## Evaluation of proposed move for Water Right Nos 968, 8210, and 21070

Proposed: Move water right nos. 968 and 8210 ID3 to the well currently authorized under water right no. 21070, located 2,582 ft to the southeast. Move water right no. 21070 to the well location currently authorized under water right nos. 968 and 8210 ID3. This change does not meet spacing requirements under GMD3 rules. A waiver of spacing rules will be required if the move is to be approved.

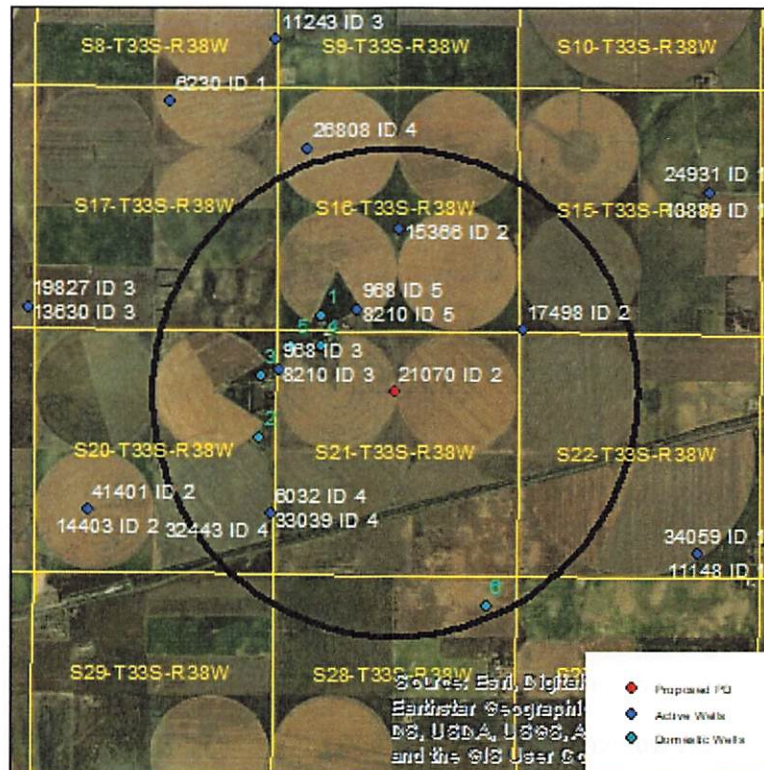
Wells within 1 mile: 968 & 8210 ID5, 15366, 17498, 6032 & 32443 & 33039, and six domestic wells, numbered on the above map.

Net drawdown exceeds the drawdown allowance of 4.0 ft for all wells within 1 mile of the proposed location. Critical well analysis is necessary on those wells.

The proposed moves are located in an area with ample saturated thickness and aquifer properties that allow for productive wells. If the east well were to pump its full authorized authority, there would likely be a noticeable effect on all neighboring wells. Critical well analysis shows that one neighboring well, authorized under water right nos. 6032 & 32443 & 33039, is critical because its pumping season saturated thickness is projected to decline by more than 40% over the next 25 years, likely causing some loss in productivity. GMD3 staff recommends limiting rate and quantity so that the well-to-well interaction effect on this well stays below 3.5 ft. Limiting the rate to **700 gpm** and quantity to **925 AF** would accomplish this goal.

Data Set: C:\Users\trevora\Documents\2021\_Moves\968\_8210\_21070\968+ Current.aqt

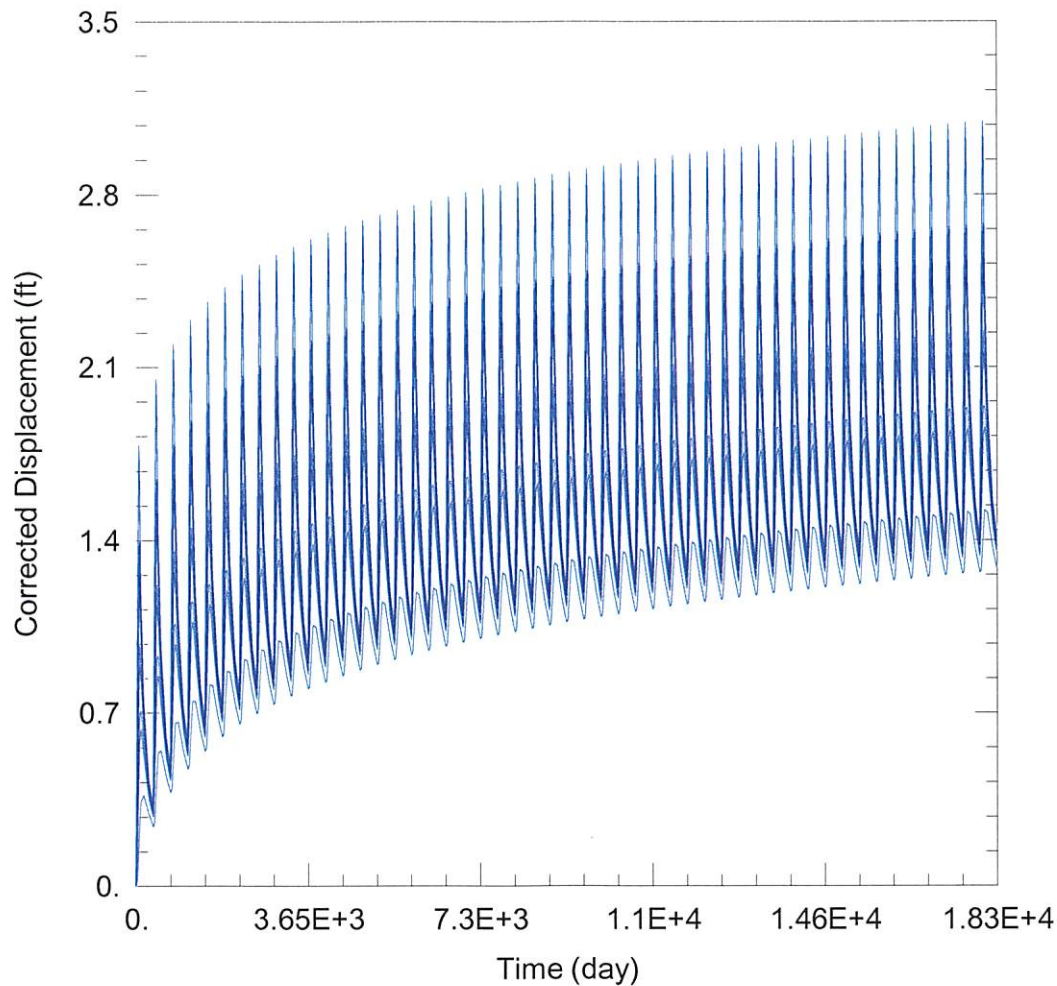
968 & 8210 ID5: Drawdown from current location = 2.99 ft  
 Drawdown from proposed location = 9.13 ft  
 Net drawdown = **6.1 ft**

15366: Drawdown from current location = 1.94 ft  
Drawdown from proposed location = 6.46 ft  
Net drawdown = **4.5 ft**

17498: Drawdown from current location = 2.16 ft  
Drawdown from proposed location = 7.03 ft  
Net drawdown = **4.9 ft**

6032 & 32443 & 33039: Drawdown from current location = 1.86 ft  
Drawdown from proposed location = 6.15 ft  
Net drawdown = **4.3 ft**
